BOOSTER PUMP No. 2
SCHEMATIC

BOXLEY HILLS TELEMETERING CABINET
INTERCONNECTION DIAGRAM

REVISED ONE LINE DIAGRAM

PRESENT LINE VALVE
CONTROL CIRCUIT MODIFICATIONS

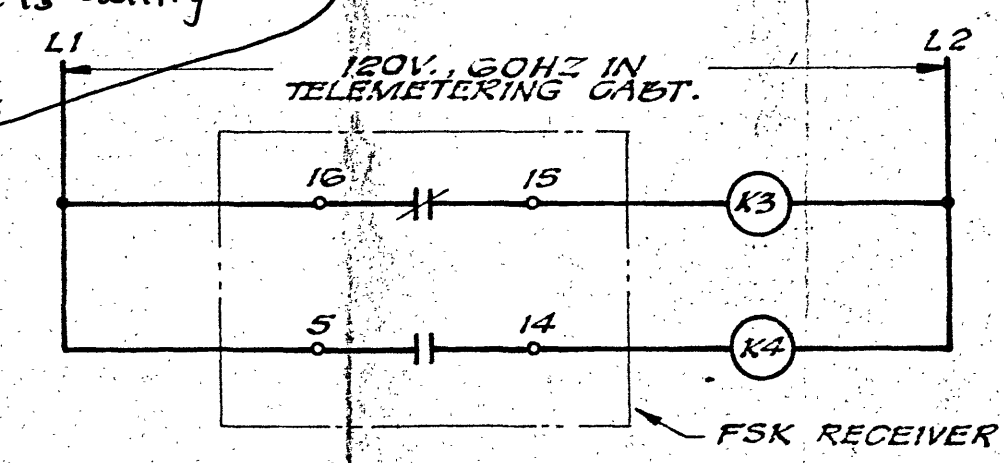
ARE BOTH pumps control circuit energized at same time?
Selector switch?
to keep one pump from calling for RV3 to open while the other is calling for RV3 to close
Ben Mullins
